RESPONSE TO COMMENTS
ON NRC OPEN ISSUES
FALLS CITY, TEXAS
UMTRA PROJECT SITE

APRIL 30, 1991

Site: Falls City, Texas Date: 4/1/91
Document: Draft TER
Commentor: NRC

FIGURE 1.1
MINING FEATURES
FALLS CITY, TEXAS, SITE

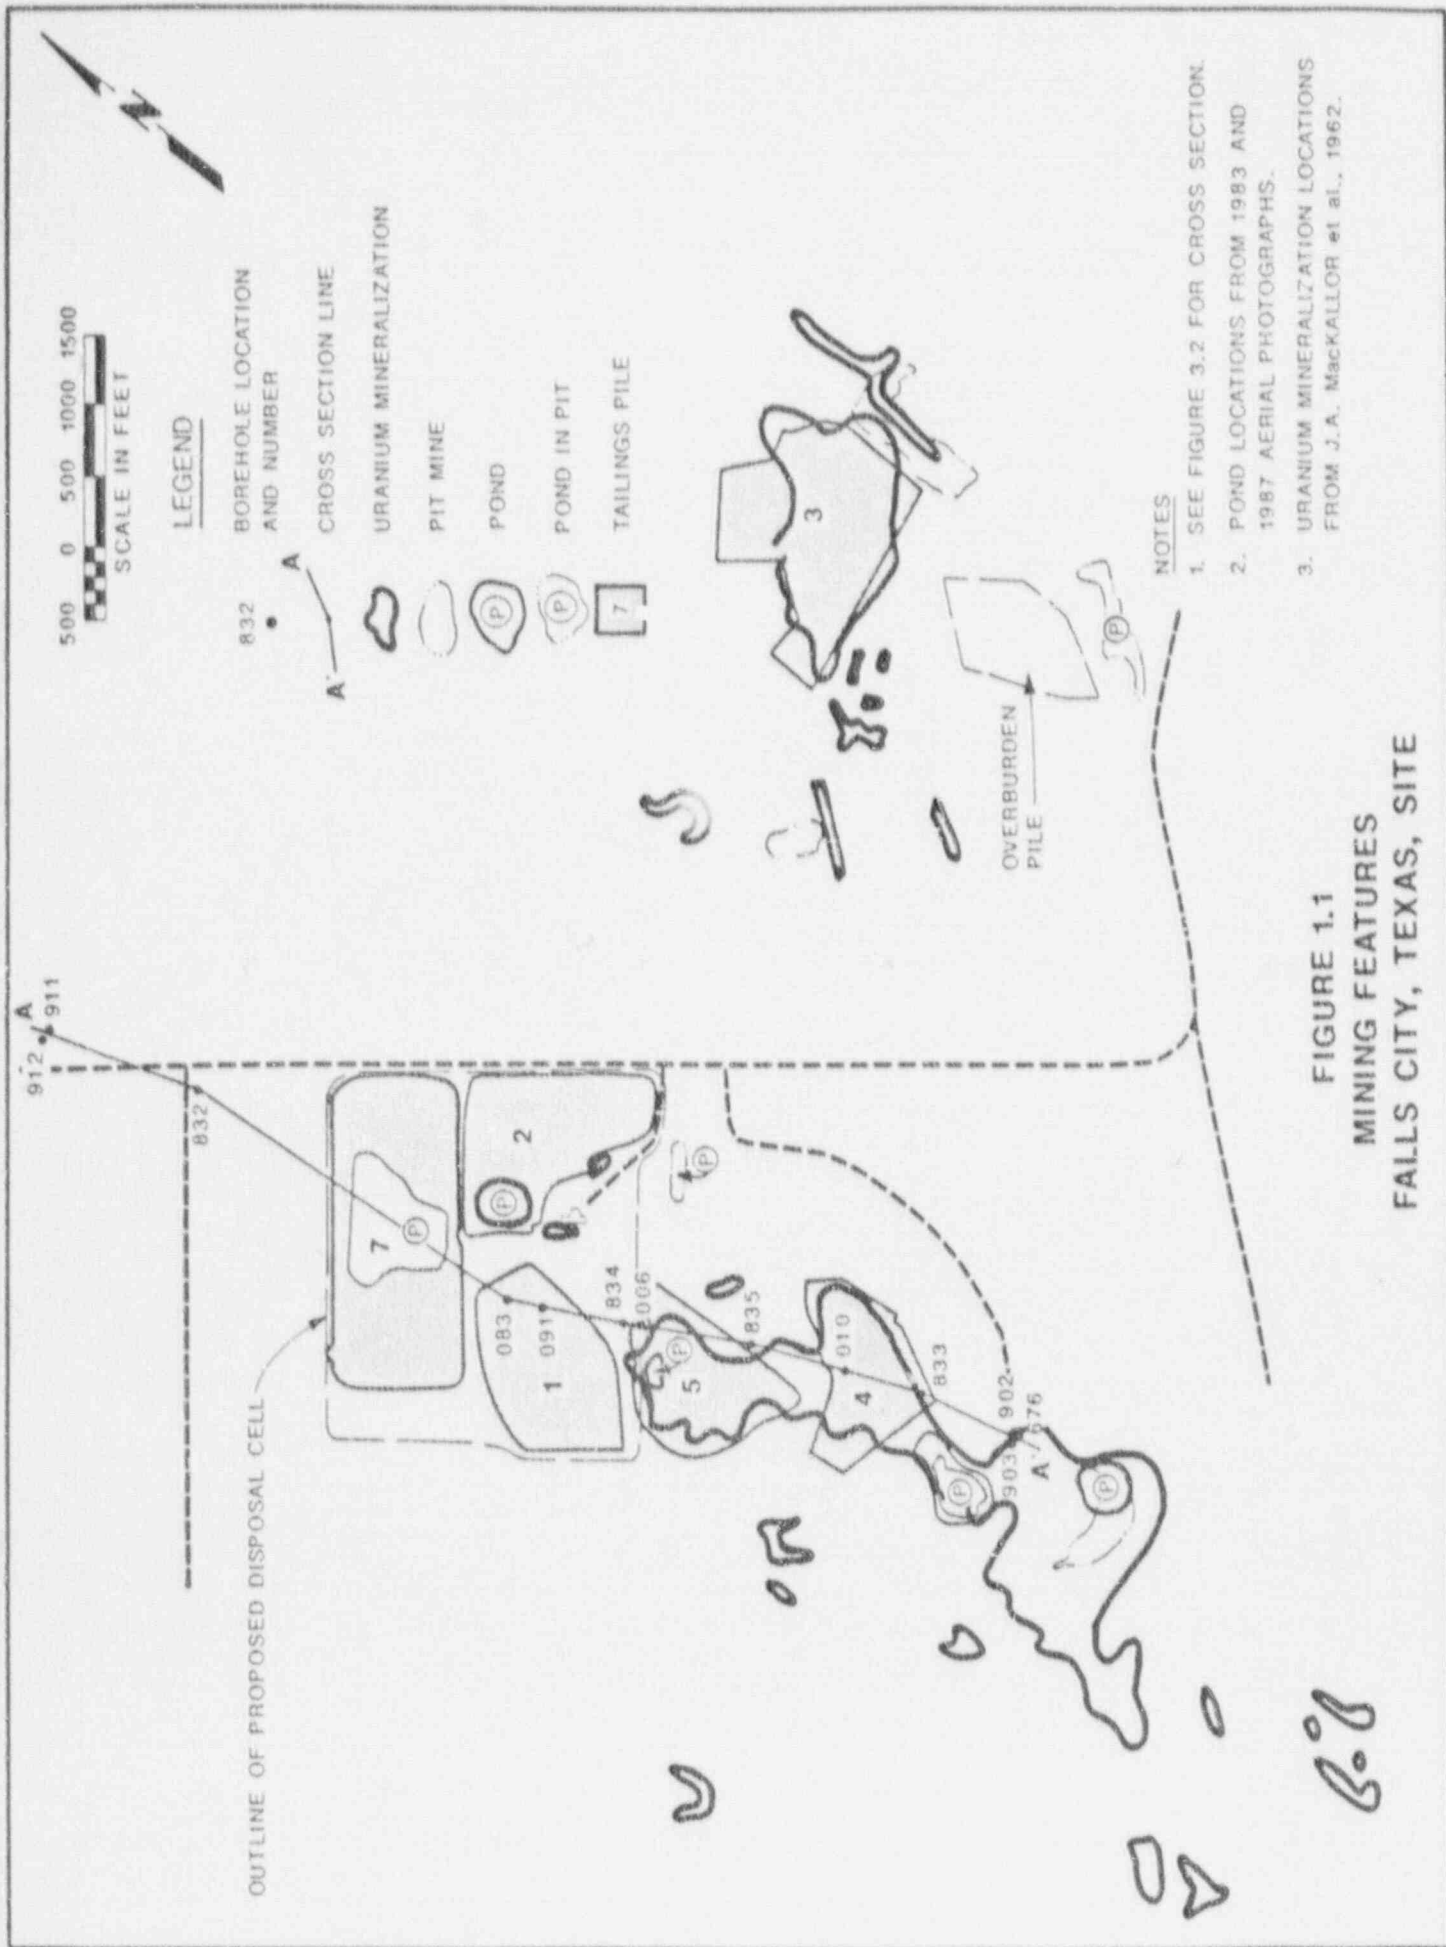
DOE needs to provide a map showing the location of all abandoned, currently being developed (mined or otherwise processed) or undeveloped natural resources in the region and site area.

Figure 1.1 has been prepared showing a modified map from Eargle et al., 1971, using additional data from aerial photos dated 1-27-83 and 2-28-83.

Plans for Implementation: The figure will be included in the final RAP.

FIGURE 3.1
MINERAL RESOURCES NEAR FALLS CITY, TEXAS, SITE

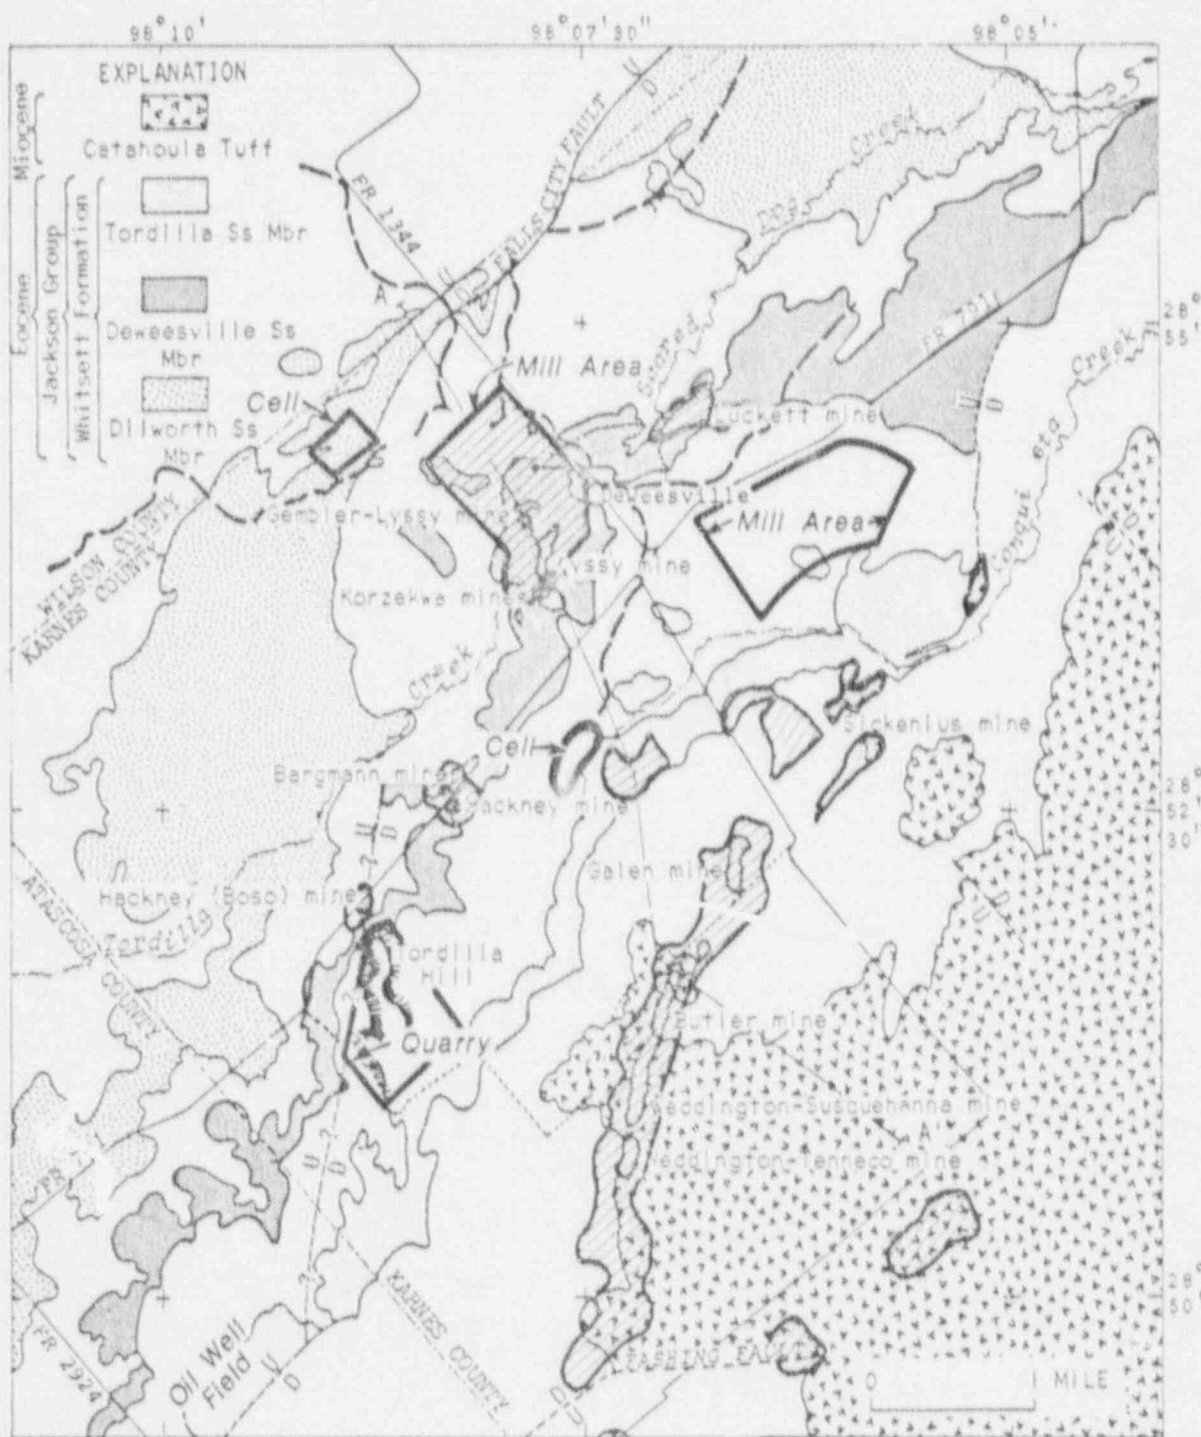
DOE needs to provide discussion of potential impacts that future development of hydrocarbons may have on the Falls City site.

Section 6.2 will be amended with the following discussion to show the potential for development of hydrocarbons that potentially could occur below the site and the very limited subsidence that may result. The potential impacts were also discussed in Sections 6.3.3 and 6.3.6.

consequence of material and thickness differences, which has been determined to not result in rupture of the cover (RAC Calculation #20-438-0601). The potential for localized differential subsidence caused by pumping of hydrocarbons is expected to occur on the faults that bound the site area rather than within the unfaulted graben block that lies between the fault systems (see Figure 3.1).
